DART SERVICE INSTRUCTION

TO AMEND INSTALLATION INSTRUCTIONS: IIN-D206-667 REV. D

DESIGN	<i>PH</i>	DART AEROSPACE LTD	
DRAWN	<i>qf</i>	HAWKESBURY, ONTARIO, CANADA	
CHECKED	ZF	DRAWING NO.	REV. S
MFG. APPR.	N/A	DSI 9346	SHEET 2 OF 2
APPROVED	NO	TITLE	SCALE
DE APPR.	CP <i>qf</i>	DEVIATION ON D206-667 & D407-667	NTS
DATE	19.09.03	COPYRIGHT © 2006 BY DART AEROSPACE LTD THIS DOCUMENT IS PRIVATE AND CONFIDENTIAL AND IS SUPPLIED ON THE EXPRESS CONDITION THAT IT IS NOT TO BE USED FOR ANY PURPOSE OR COPIED OR COMMUNICATED TO ANY OTHER PERSON WITHOUT WRITTEN PERMISSION FROM DART AEROSPACE LTD.

FIGURE 1 - INSTALLATION OF DART CROSSTUBES ON BHT/AAI SKIDTUBE

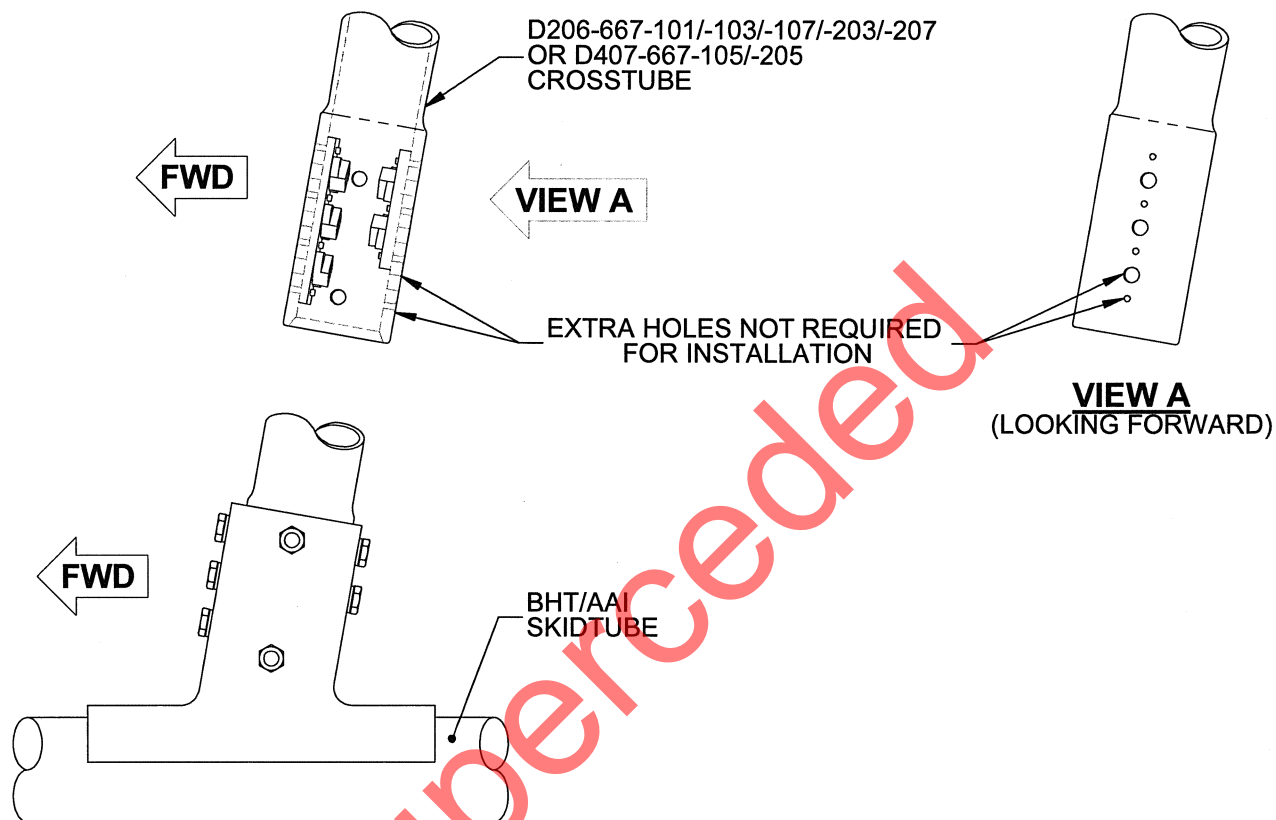
THE FOLLOWING D206-667-101/-103/-107/-203/-207 AND D407-667-105/-205 CROSSTUBES HAVE EXTRA HOLES DRILLED ON THE AFT SIDE OF THE CUFFS. THIS HOLE IS NOT REQUIRED FOR INSTALLATION OF DART CROSSTUBES ONTO BHT/AAI SKIDTUBES AS SHOWN IN FIGURE 1.

CUSTOMERS RECEIVING CROSSTUBES AT CHG 002 PRIOR TO 2006/08/08 SHOULD CONTACT DART FOR DISPOSITION IF INSTALLING THE DART CROSSTUBES ONTO BHT/AAI SKIDTUBES PER IIN-D206-667 REV. D.

CUSTOMERS RECEIVING CROSSTUBES AT CHG 002 PRIOR TO 2006/08/08 TO BE INSTALLED WITH DART SKIDTUBES MAY FIND THAT THE SUPPORTS HAVE BEEN INSTALLED BACKWARDS. THE SUPPORTS SHOULD BE REMOVED AND RE-INSTALLED PER ICA-D206-667.
